Approved Document B

The composite aerial image, provided by the applicant, depicts house type A2: *see right*.

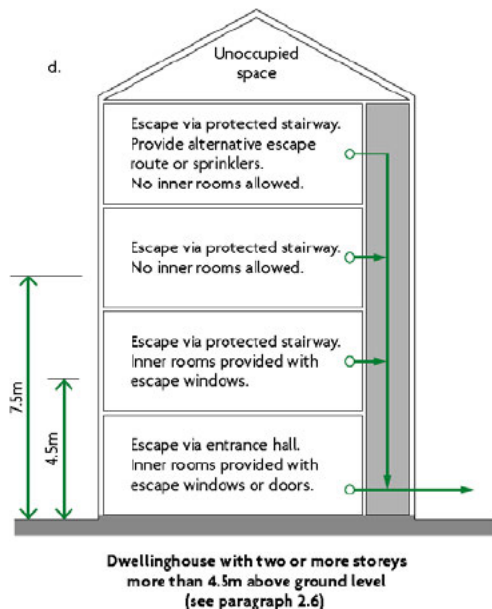
The height of the top floor, appears to be the same height as that of a four storey dwelling.

I say this because the podium, on which the dwellings sits, is the height of a storey.

Looking to where the steps, on the left, lead down to the garden, it can be seen the height of the podium is maintained, where it meets the embankment.

It states dwellings with storeys at this height (or above) must provide an alternative escape route, for floors at that height, or a sprinkler system.

Looking at the drawing of the plans, there does not appear to be an alternative escape route.

Also, I've found no mention of a sprinkler system, in any of the other submitted files I've seen.

Without one of these two options, I believe this dwelling would fail to satisfy fire safety standards.
